Access Compliance Report

Public Rights-of-Way

(Curb Ramps)

Intersection ID: 27719	Main Street: BREM_LN	Cross Street: FLENNIGAN_WY	Location: NW
ADA ID: 91DA86D04754	Ramp Type: Perp	Initial Pass/Fail: Fail	Overall Compliance: No
Severity Score: 25			
Codes/Mitigation Info/Possible Solution		Field Measurements/Component Compliance

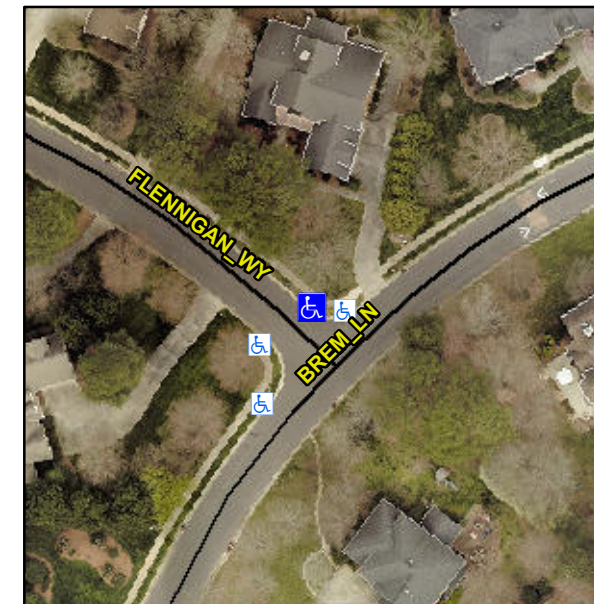
Not Found, R304.5.3

Compliance	Description	Data	Compliance	Description	Data
N/A	Ramp Length (in)	50.0	Yes	Ramp Slope (%)	3.9
Yes	Ramp Width (in)	48.0	No	Ramp XSlope (%)	9.2
N/A	Flare Type LT	N/A	N/A	Flare Type RT	N/A
N/A	Flare Slope LT (%)	N/A	N/A	Flare Slope RT (%)	N/A
N/A	Flare Traversable LT?	N/A	N/A	Flare Traversable RT?	N/A
N/A	Landing Length (in)	N/A	N/A	DWS Provided?	N/A
N/A	Landing Width (in)	N/A	N/A	DWS Contrast?	N/A
N/A	Landing Slope (%)	N/A	N/A	DWS Length (in)	N/A
N/A	Landing X Slope (%)	N/A	N/A	DWS Full Width?	N/A
N/A	Landing Curb? (Y/N)	N/A	N/A	DWS Offset (in)	N/A
N/A	Shared Landing?	N/A			
N/A	Gutter Ponding?	N/A	N/A	Gutter Slope (%)	N/A
N/A	Gutter Lip Ht (in)	N/A	N/A	Gutter X Slope (%)	N/A
N/A	Painted X Walk1?	No	N/A	Painted X Walk2?	N/A
	X Walk 1 Direction	To SW		X Walk 2 Direction	N/A
N/A	X Walk 1 Width (in)	N/A	N/A	X Walk 2 Width (in)	N/A
	X Walk 1 Slope (%)	0.3		X Walk 2 Slope (%)	N/A
	X Walk 1 X Slope (%)	3.6		X Walk 2 X Slope (%)	N/A

Remove & Replace Entire Ramp.
